# **Intel® Mobile Celeron™ Processor Specification Update**

Release Date: August 1999

Order Number: 244444-007

Figure 2. Workaround Flowchart: SMBALERT#-Driven System

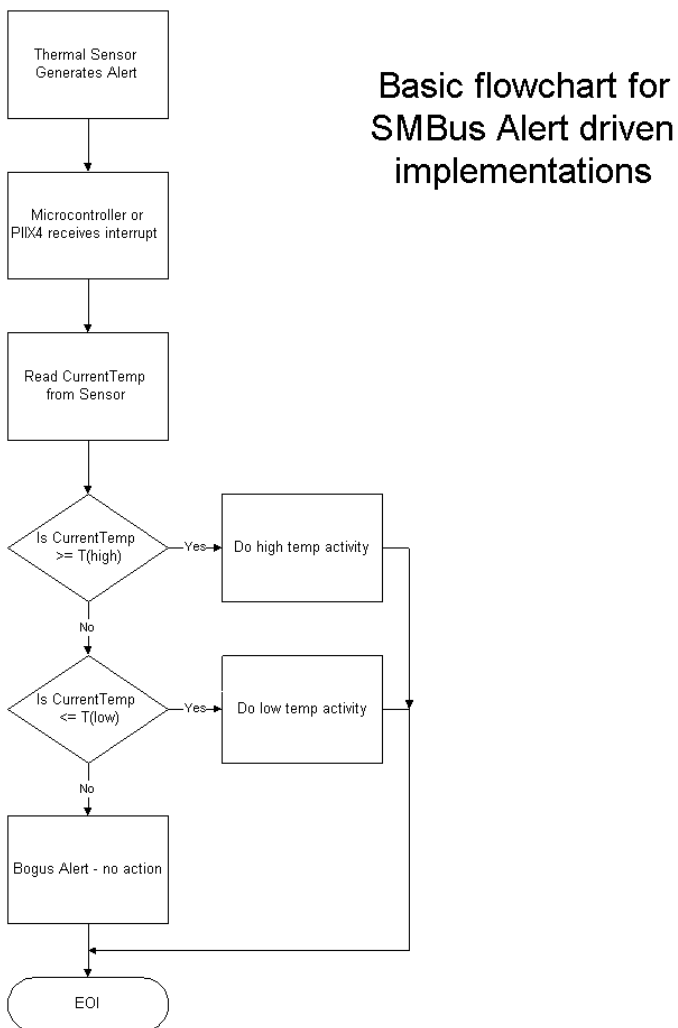
**WORKAROUND:** Three different (mutually exclusive) workarounds are possible:

1. Before servicing an interrupt from the thermal sensor, read and compare the processor thermal reading with the threshold limits ( $T_{HIGH}$  or  $T_{LOW}$ ). Figures 2 and 3 provide basic flowcharts for the implementation of this workaround in an interrupt driven system.
2. If the firmware implemented polls the Status Register only, then before taking any action, re-read the temperature register and do a comparison with the alarm threshold limits ( $T_{HIGH}$  or  $T_{LOW}$ ) to determine if the value is actually still within the temperature window.
3. Use a temperature polling scheme to monitor the processor temperature.

**Figure 5.3. Surface-Mount BGA1 Package—Top and Side View**

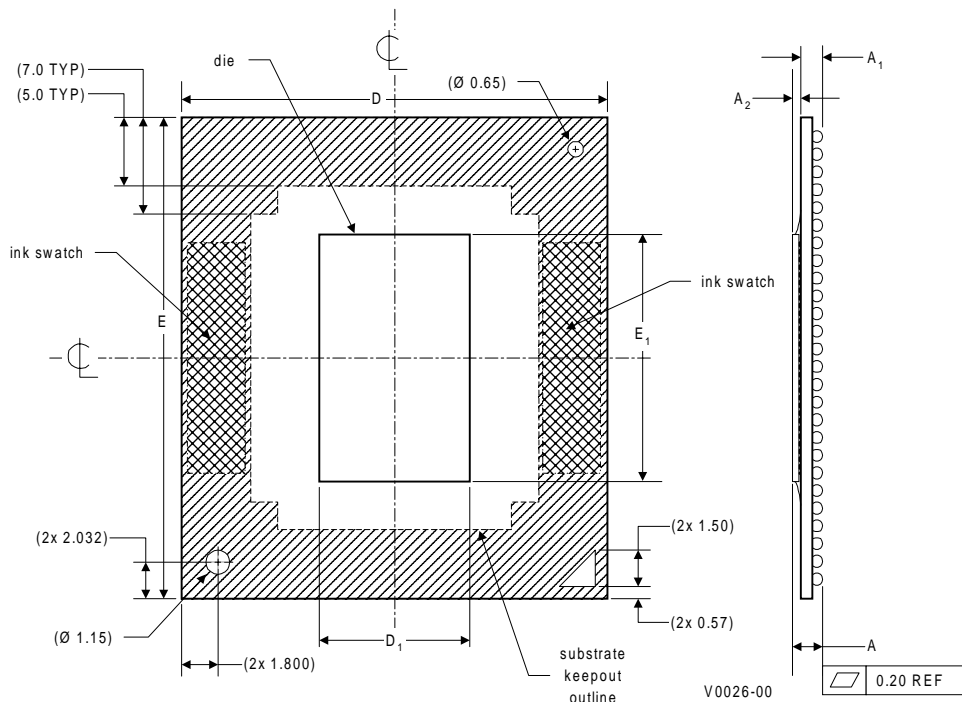
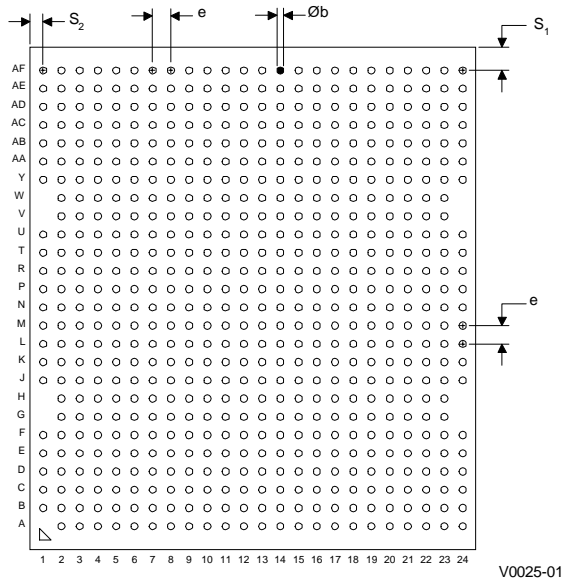
The following table and figures show the updated mechanical specifications for the BGA1 package, listed as Table 5.2, Figure 5.3 and 5.4, respectively, in the *Intel® Mobile Celeron™ Processor in BGA Package at 333 MHz, 300 MHz and 266 MHz* datasheet.

1. The number shown here is different from that in last month's specification update. The maximum reference number is used.

**Figure 3.3 Generic Clock Waveform**

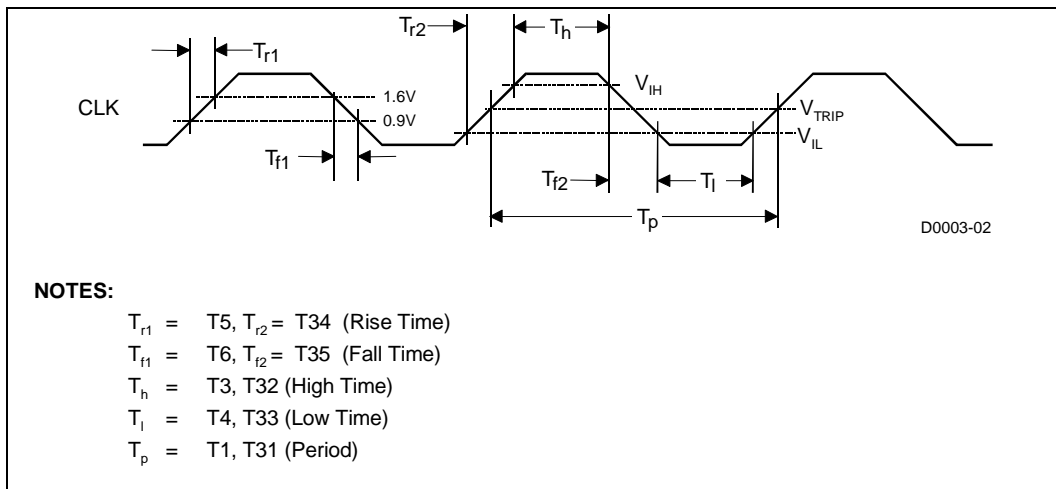
Figure 3.3 in the *Intel® Mobile Celeron™ Processor in  $\mu$ PGA1 and BGA1 Packages at 366 MHz, 333 MHz, 300 MHz, and 266 MHz* datasheet (Order Number 245112-003) has been updated. The following figure is to replace the one in the above document.
